SH2 Remutaka Slow Vehicle MACT 1982 Bays Post Construction Safe System Audit

14 June 2024

Date: 14 June 2024 Reference: 5 C4708.00 Status: Final

Figure 5: Location of end hatching relative to geometry making returning to the through lane challenging.

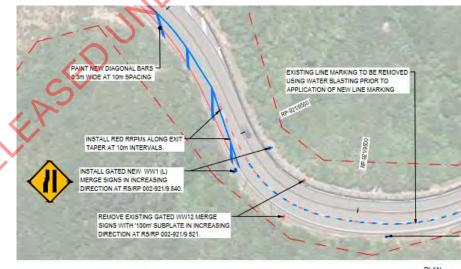
The Slow Vehicle Bays are marked with a continuity line throughout the length of the lane, with a hatched area on the terminal of the Slow Vehicle Bay (SVB). The current marking layout requires Slow Vehicle Bay users to giveway to passing traffic to re-enter the "through" lane.

Due to the tortuous nature of SH2 Remutaka, on some slow vehicle bays it is difficult to sight other road users approaching from behind while occupying the Slow Vehicle Bay. Locations where visibility was challenging include:

- Wairarapa-bound, RS931, RP1.5
- Hutt-bound, RS921, RP9.5

Limited visibility occurred on both left hand and right-hand curves. On left hand curves the wing mirror view is either into the hillside or over the cliff rather than over the lane. On right hand curves the roadside topography can obscure visibility. The challenging visibility distracts drivers attention away from the carriageway ahead of them, increasing handling errors or potentially striking an object. Some SVB users may come to a stop to identify a gap in traffic.

End taper rate and subsequent curve geometry forms a challenging manoeuvre for SBV users, increasing the risk of handling errors resulting in loss of control movements. The SBV users have complicated tightening and reverse curves to negotiate to return to the through lane in most MFORMATION locations.

Recommendation: Consider remarking slow vehicle bay terminal merge(s) to reduce conflict between various road users, particularly; extend short slow vehicle bays,

consider length of taper, and geometry of taper. End continuity line prior to taper as designed

Figure 8: Curve geometry and hatched entry/taper for Slow Vehicle Bay

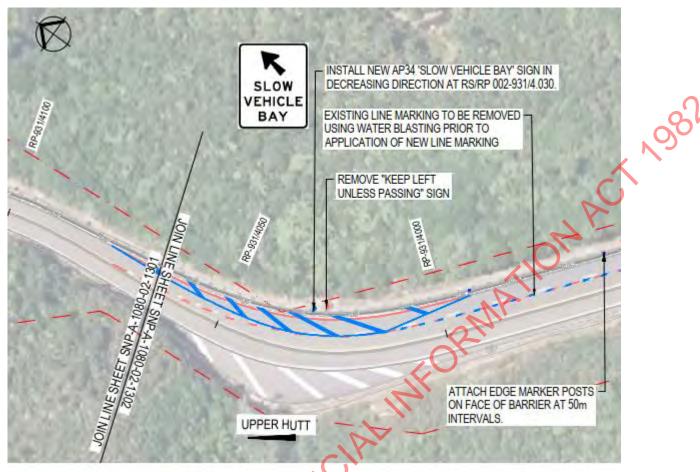
The Slow Vehicle Bays are marked with a hatched area on the entry tapers. The current marking layout encourages some SVB users to manoeuvre around the hatched area and then enter the SVB lane, in some cases at a sharp angle or tightening horizontal alignment especially around curves. This makes entering the SVB complicated, in regard to vehicle handling, as the driver tends to require three movements negotiating the curve, tightening into the bay and then another tight reverse curve to position the vehicle into the lane and follow the road alignment.

If entering over the entry hatching, vehicle handling is simpler typically consisting of a single movement. However, the hatched markings may cause some drivers to refrain entering this area as it is perceived as an area for emergency / wider vehicle turning use.

Recommendation: Consider removine hatching having taper at the current diverge. If hatching retained, consider shifting the AP34 "Slow Vehicle Bay" sign to the start of the hatched area to encourage direct entry over the hatching to improve entry negotiation.

Figure 9: Reduced offset between through traffic lanes.

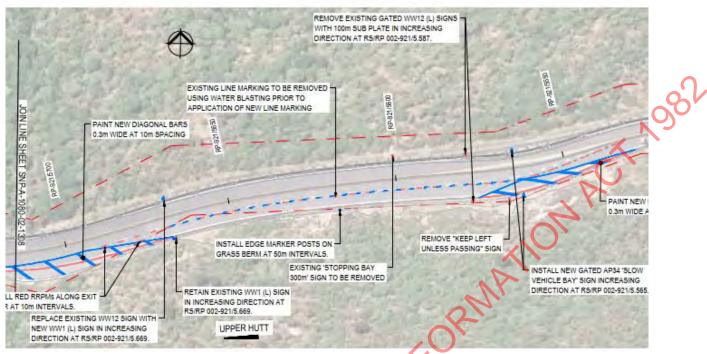
Under the previous layout, within the passing lanes, the through traffic lane was on the left-hand side of the carriageway. With a Slow Vehicle Bay, the through traffic lane is in the centre of the carriageway, reducing the offset between the opposing through traffic lanes, increasing the head-on crash risk when road users lose control. SH2 Remutaka has a high number of loss of control crashes.

Recommendation: Encourage through vehicle movement into left hand lane by diverging from the centre line rather than the edgeline.

Figure 10: Short Slow Vehicle Bay with ineffective passing length.

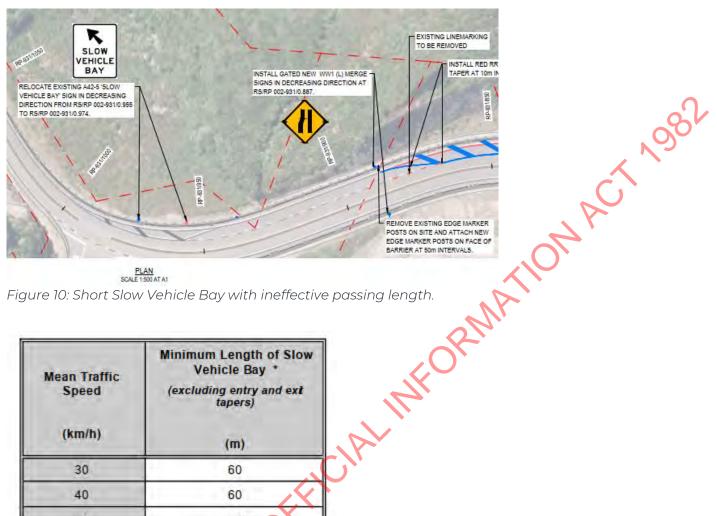
Most of the Slow Vehicle Bays have a continuity line length of approximately 150 m to 250 m. However, three are short with continuity line lengths of approximately 100 m or less. Short Slow Vehicle Bays limit the number of vehicles which can be safely passed, unsafe passing manoeuves increase the head-on crash risk. Locations with short lengths include:

- Wairarapa-bound, RS931, RP0.9
- Hutt-bound, RS921, RP6.5
- Wairarapa-bound, RS921, RP4.2

For short Slow Vehicle Bays the relative potential speed differential, vehicle lengths, and acceleration rates on significant slopes limit the ability of effective Slow Vehicle Bay use. Austroads Guide to Geometric Design² refers to MOTSAM Part 1 & Part 2 for lengths (see Figure 11 below).

Recommendation: Carry out speed surveys on entry into all Slow Vehicle Bays to determine if there is adequate length for a safe passing manoeuvre based on vehicle speeds, if not convert into hatched area.
